APPLICATION NO.	FILING DATE	FIRST NAMED INVENTOR	ATTORNEY DOCKET NO.	CONFIRMATION NO.
09/622,674	10/02/2000	John Shuker	16210-0107	2741
23370 JOHN S. PRAT	7590 07/19/201 T, ESO	EXAMINER		
KILPATRICK STOCKTON, LLP			SULLIVAN, MATTHEW J	
SUITE 2800	CHTREE STREET 00		ART UNIT	PAPER NUMBER
ATLANTA, GA	A 30309		3677	
			MAIL DATE	DELIVERY MODE
			07/19/2010	PAPER

DETAILED ACTION

Claims 1-7 are rejected under 35 U.S.C. 103(a) as being unpatentable over Braithwaite, U.S. Patent 1,207,270 (12/5/16) in view of Riblett, U.S. Patent 5,412,842 (5/9/95).

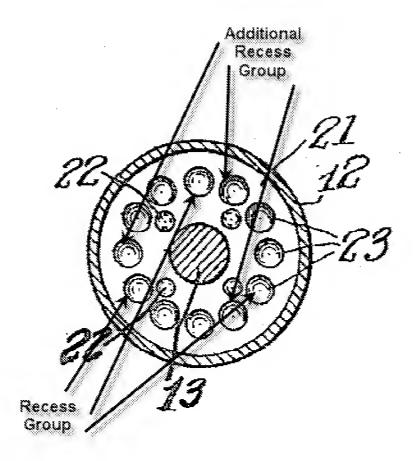
Regarding **Claim 4**, Braithwaite clearly teaches the recess arranged in one or more groups corresponding to respective check positions, the recess in each group corresponding in number and circumferential spacing to the number and circumferential spacing of the check members such that at a desired check position all check members are located in a corresponding recess of the group (see below).
